N5182A-13A

Information Only Service Note

N5182A MXG Vector Signal Generator

The Problem – The N5180-60024 LCD Assembly is No Longer Available

Figure 2 - LED Backlight Driver Board Connection

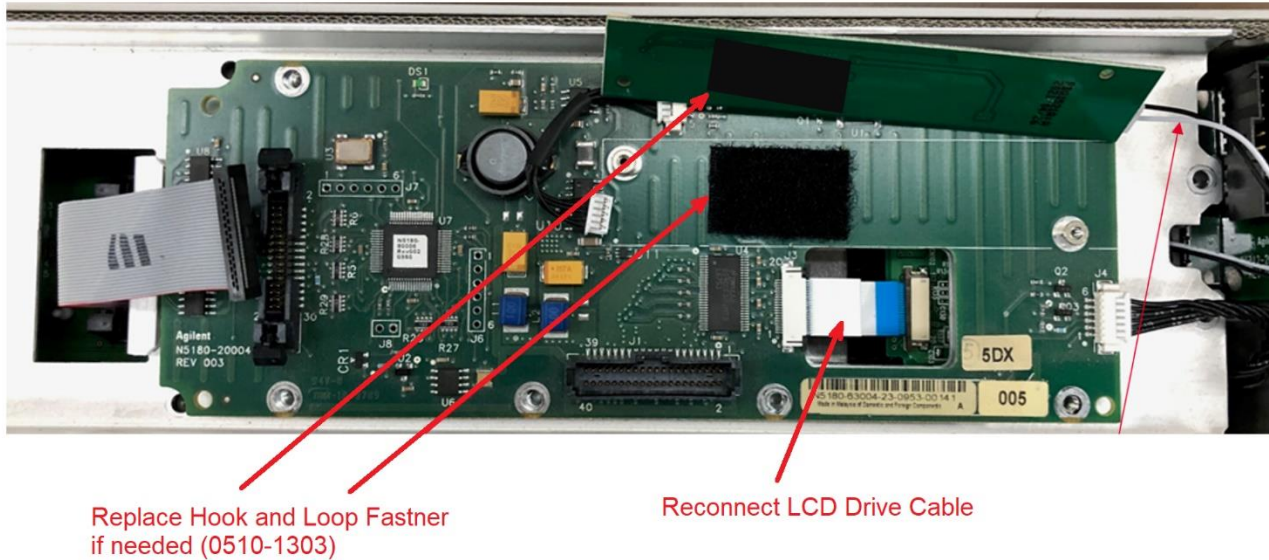
2. Install the replacement LCD into the front frame assembly
3. Install the replacement LED Backlight Driver board using the same location and screws for the original backlight driver board, as shown in Figure 2 and Figure 3

Figure 3 - LED Backlight Driver Board Attachment

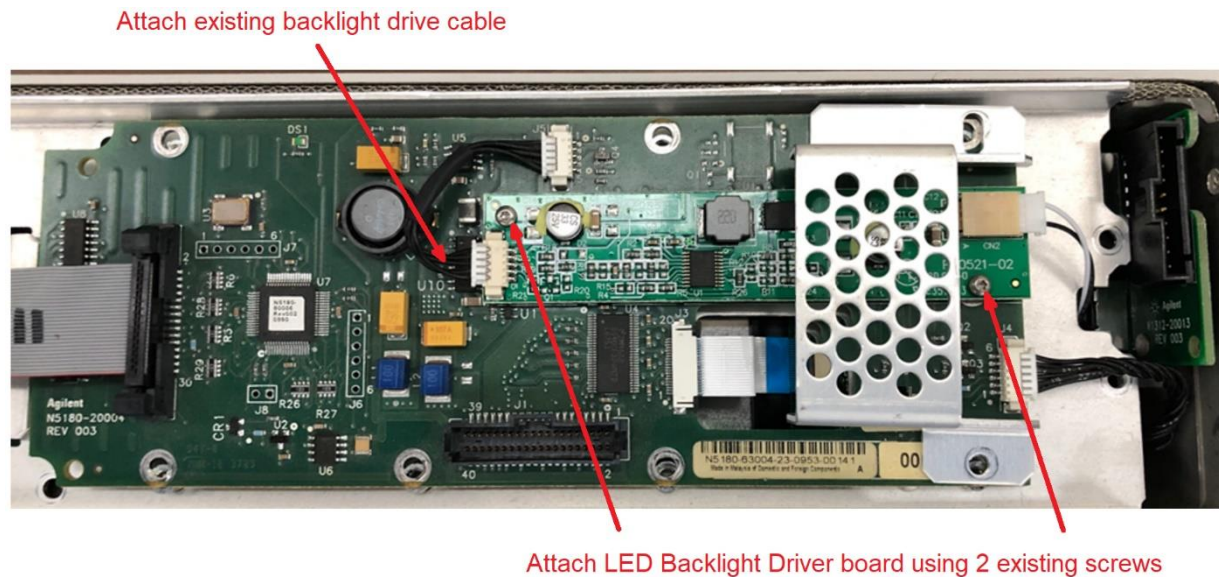
4. Attach the existing backlight drive cable to the new LED backlight driver board, as shown in Figure 3
5. Once the assembly is completed, turn the instrument on and verify operation.
6. If the display needs to be adjusted press **Utility**, **Display** and adjust the **Contrast**, as shown in
